| Intersection ID: 42739 | Main Street: CALDWELL_RIDGE_PY | Cross Street: LEES_CROSSING_DR | Location: | SW |
| ADA ID: 237D2FA98379 | Ramp Type: PerpDiag | Initial Pass/Fail: Fail | Overall Compliance: No | Severity Score: 10 |

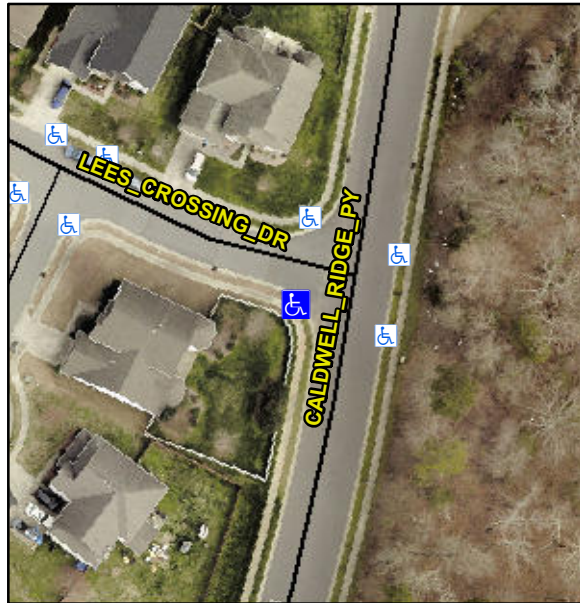
Not Found, R304.5.1, R304.5.3

| Compliance | Description | Data | Compliance | Description | Data |
|------------|-----------------------|-------|------------|-----------------------------|-------|
| No | Ramp Width (in) | 47.5 | No | Ramp XSlope (%) | 2.8 |

Remove & Replace Curb Ramp With Two New Directional Ramps or Equivalent.
